FINAL PRODUCT/PROCESS CHANGE NOTIFICATION #20272Generic Copy

TITLE: Qualification of Serial Microwire CAT93C86, CAT93C76, CAT93C46/46R and SPI CAT64LC40 EEPROM devices for fabrication at ON Semiconductor's Gresham, Oregon Wafer Fab.

AFFECTED CHANGE CATEGORY(S): ON Semiconductor Fabrication Site

Appendix – PART IDENTIFICATION

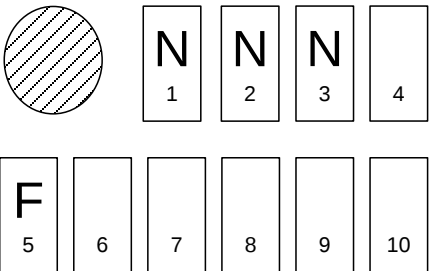
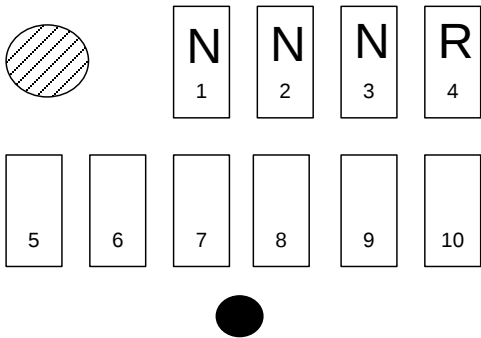
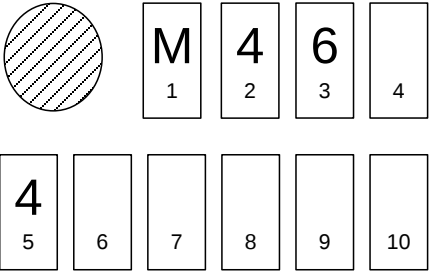
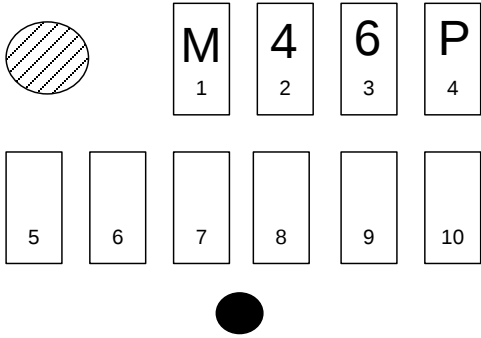
The top package marking for the new Gresham die versus current marking used for the OKI die is shown in the attached Appendix. The new top package marking used for newly introduced Gresham die reflects the integration of former CSI (Catalyst) into ON Semiconductor, and provides for easier identification of device and die revision.

- 1-5: Product Code
- 6: Product Revision
- 7: Assembly Location Code
- 8: Production Year
- 9: Production Month
- 10-12: Assembly Lot Number
- : Pb-free microdot

- 1-5: Product Code
- 6: Product Revision
- 7: Assembly Location Code
- 8: Production Year
- 9: Production Month
- 10-12: Assembly Lot Number
- : Pb-free microdot
